Submission to Draft Amendment C295 to the Casey Planning Scheme - Casey Fields South (Employment) and Devon Meadows Precinct Structure Plan (PSP)

Submission to draft Amendment C295 - Casey Planning Scheme

Casey Fields South (Employment) and Devon Meadows
Precinct Structure Plan

Figure 4 - Updated Plan 6 (Water) – MAB properties

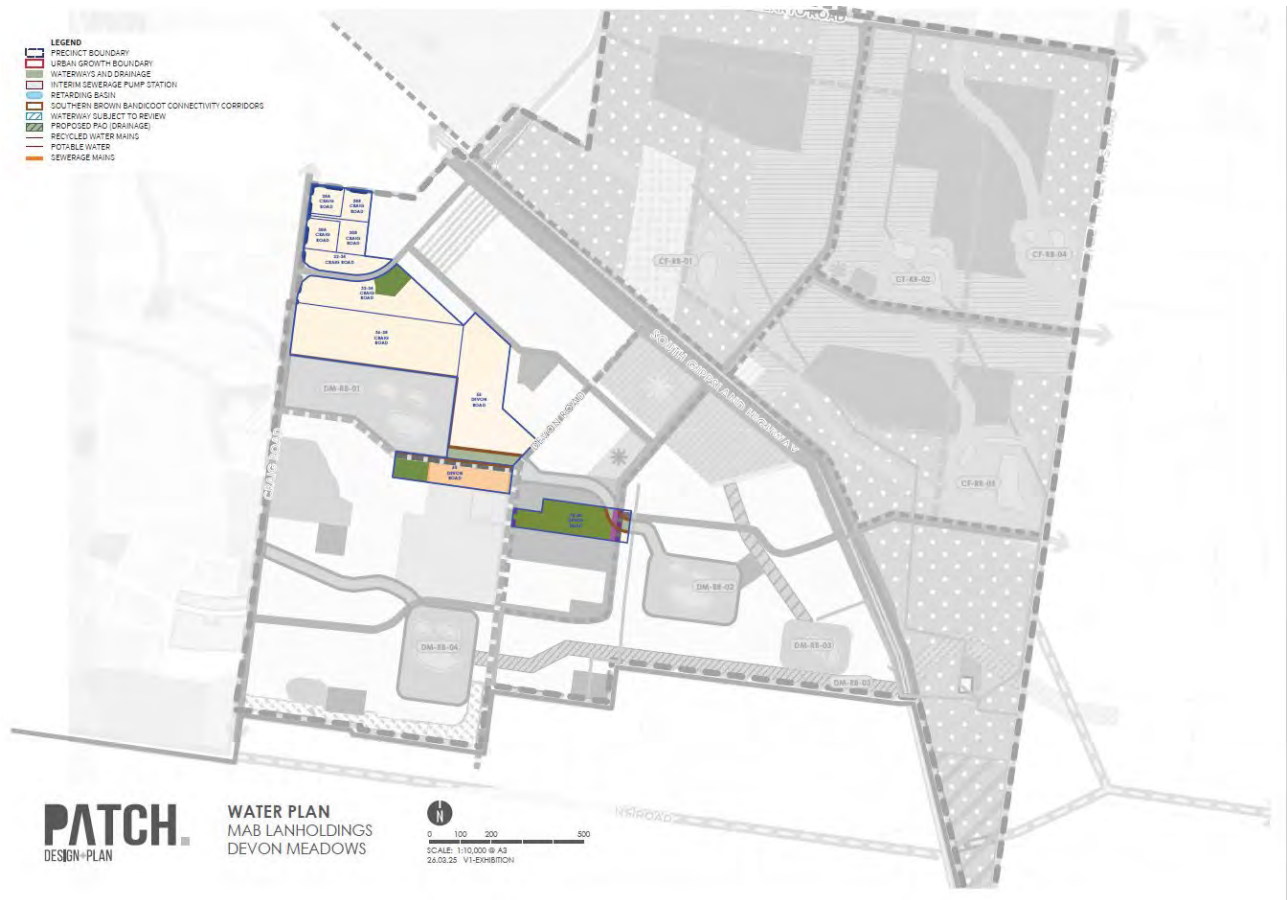
Figures 3 and 4 highlight the consolidated suite of changes to Plan 6 (Water) and specifically MAB's land for further consideration and agreement with the VPA and Melbourne Water.

Prior to public consultation of the PSP, MAB highlighted to the VPA and MWC through engineering-led meetings that the proposed constructed waterway in the north-western part of the DMPSP is not required to convey the low volumes of stormwater flows from Junction Village and that it should be removed to enable an improved urban structure. This change will also increase the net developable area of the PSP which in turn will increase the PSP yield and increase the ICP levies available to Council from the standard levy.

Figure 5 – Updated Plan 9 (Infrastructure and Development Staging)

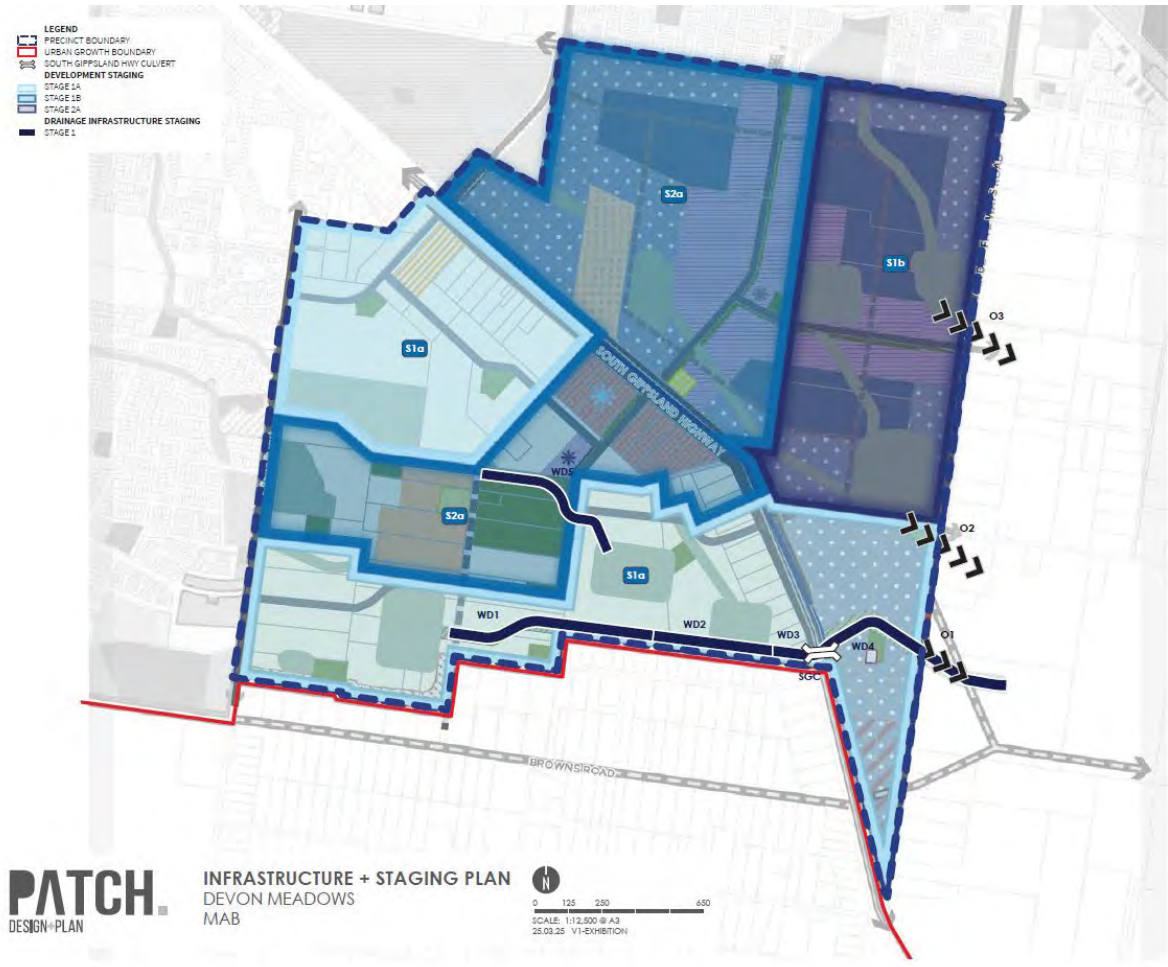
Plan 9 of the DMPSP should be amended (refer to **Figure 5** below) to reflect MAB’s alternative drainage scheme as:

- It leverages the use of the existing and underutilised MWC land for drainage purposes by “unlocking” the area of land in S1A shown in Figure 5 for immediate urban development; and
- The northern section of MAB’s revised S1A is not reliant on the acquisition of land for WD1-WD4 or the South Gippsland Culvert identified in Plan 9 in the southern portion of the PSP and only requires the necessary works to construct a wetland / retention basin in line with MWC DSS requirements.

Figure 8 - Updated Active Open Space

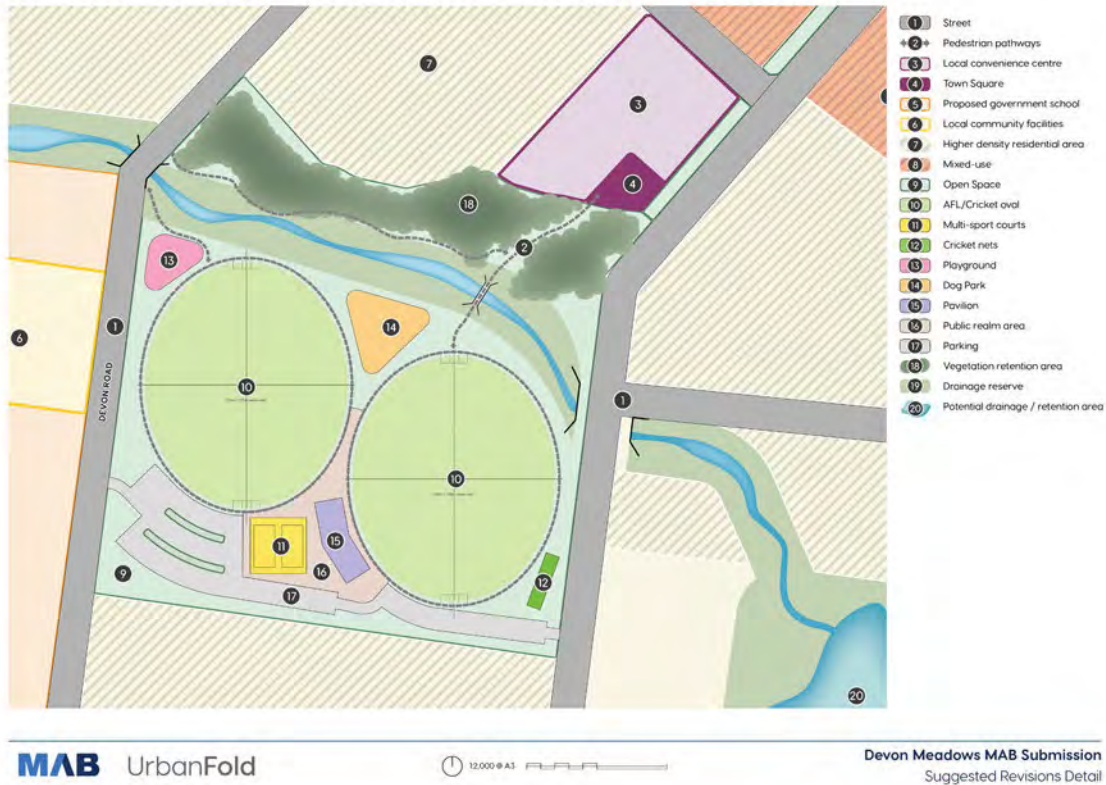
Figures 7 and 8 below depict MAB’s revised layout of the Active Open Space as a result of the re-alignment of the constructed waterway. Two senior AFL ovals have been shown; however, the same

principle would apply to the delivery of soccer facilities on the reserve. The relocated waterway provides greater flexibility for the delivery of soccer facilities.

Figure 7 – Proposed Concept Plan (Verve)

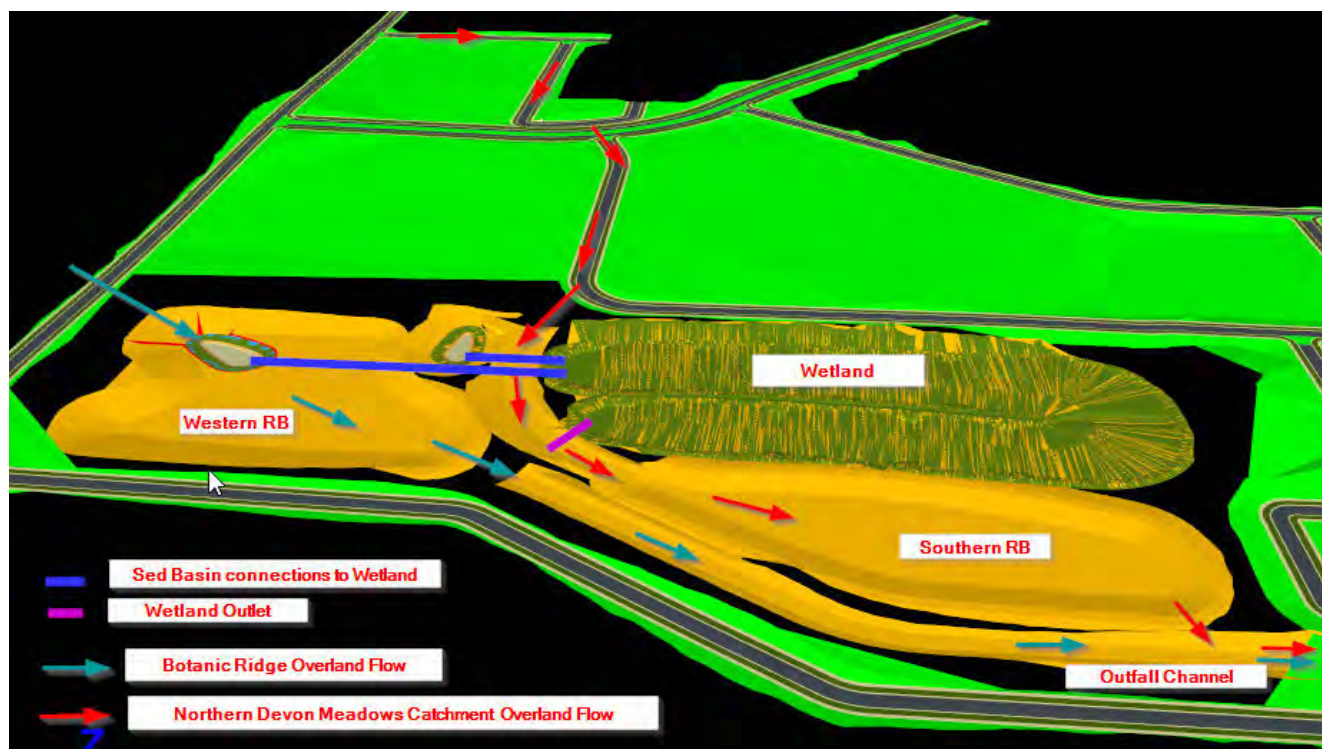
Verve Projects has considered the previous work and investigated opportunity to maximise the treatment area and storage volumes as shown in Figure 7 below.

The updated concept design provides an inlet to the western sedimentation basin which is incorporated within the retarding basin for the Botanic Ridge catchment. The minor flows are piped from the sediment basin to the wetland for treatment. The larger event flows will be retarded by the basin and discharged to the outfall channel along the southern boundary. This arrangement is the same as the SWS concept design.

Figure 17 – Draft Devon Meadows PSP Plan 9

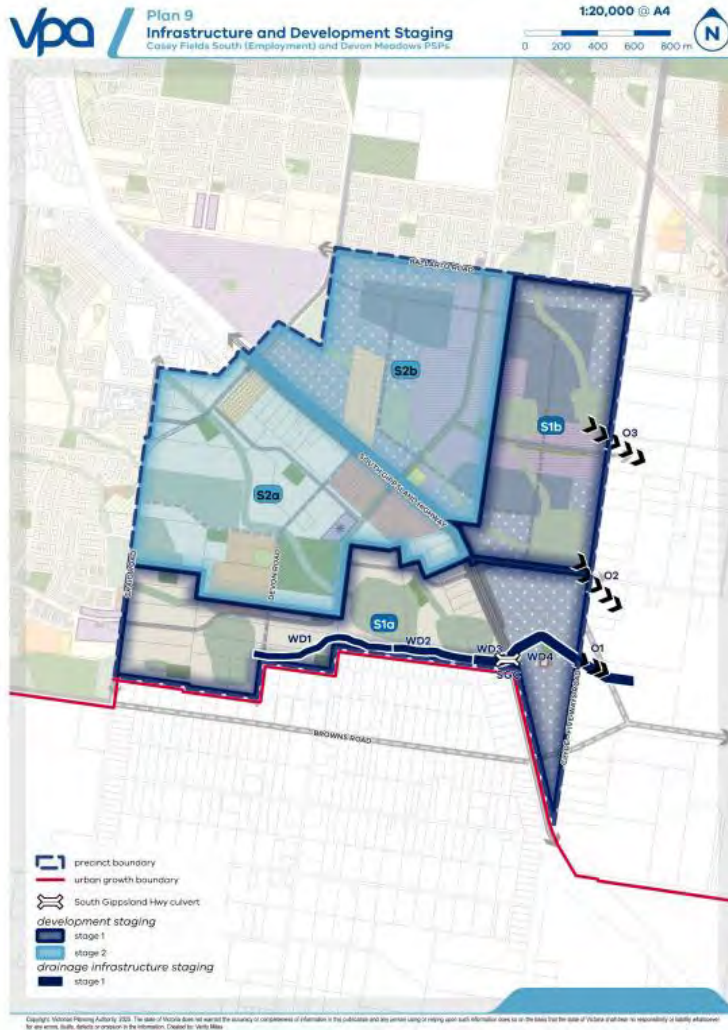
The PSP (March 2025) contains three “Requirements” which relate to staging, as follows:

R19	Staging of infrastructure and development must be generally in accordance with Plan 9 - Infrastructure and Development Staging and Table 8 - Water Infrastructure, and must provide for the timely provision and delivery of infrastructure to the satisfaction of Melbourne Water and the responsible authority.
R27	Prior to the issue of a statement of compliance for any stage of the subdivision of a PSP parcel or the commencement of development of a PSP parcel, DSS assets WD1, WD2, WD3, SGC, WD4, O1, O2, O3 identified within the respective stage shown on Plan 9 Infrastructure and Development Staging and Table 8 Water infrastructure must be delivered unless otherwise agreed to in writing by Melbourne Water and the responsible authority.
R28	<p>Development must provide for the delivery of ultimate waterway and drainage infrastructure as detailed in the DSS, including stormwater detention and quality treatment, and outfalls to the satisfaction of Melbourne Water and the responsible authority.</p> <p>Where it can be demonstrated that this is not possible, development proposals must demonstrate how any interim solution adequately manages flow rates, treats stormwater generated from the development (without causing adverse impacts to the other properties within or outside the precinct, the environment, cultural heritage, or other infrastructure), to the satisfaction of Melbourne Water and the responsible authority.</p> <p>An interim solution will not be considered for assets WD1, WD2, WD3, SGC, WD4, O1, O2, O3. These assets must be delivered in their ultimate form.</p> <p>Development construction and interim solutions must avoid or mitigate the risk of soil erosion and waterway degradation.</p>

Figure 19 – Sketch layout as shown in the draft PSP

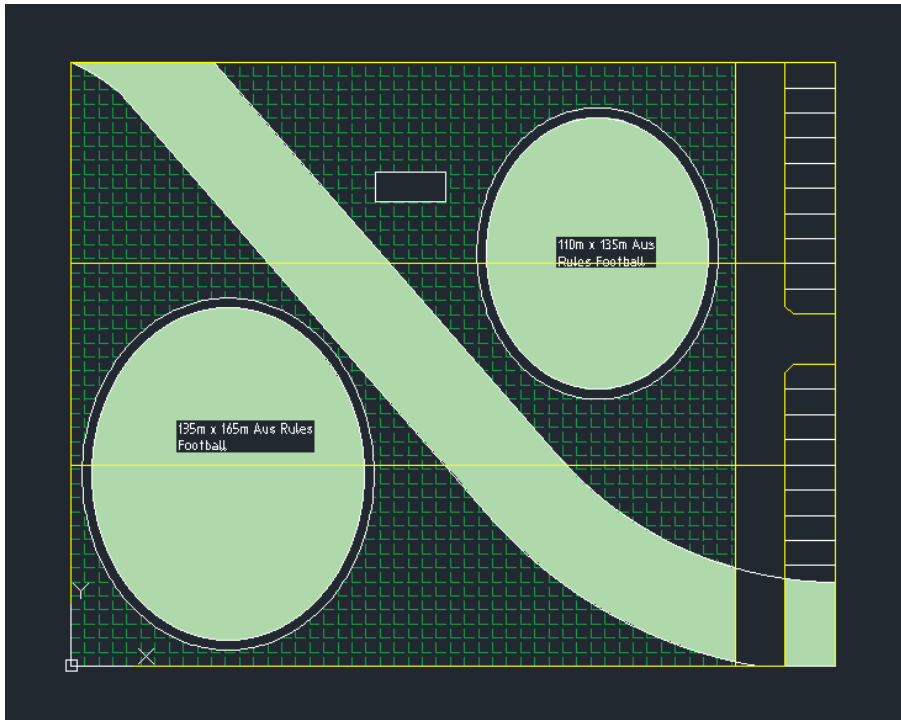
A high-level analysis has been undertaken on the Active Open Space Area and how it would be impacted by the proposed constructed waterway which bisects the area, significantly limiting the usability of the facilities.

Given the constraints placed on the sports facilities by the proposed diagonal waterway, an alternative waterway alignment and configuration of the AoS is provided below in **Figure 20**.
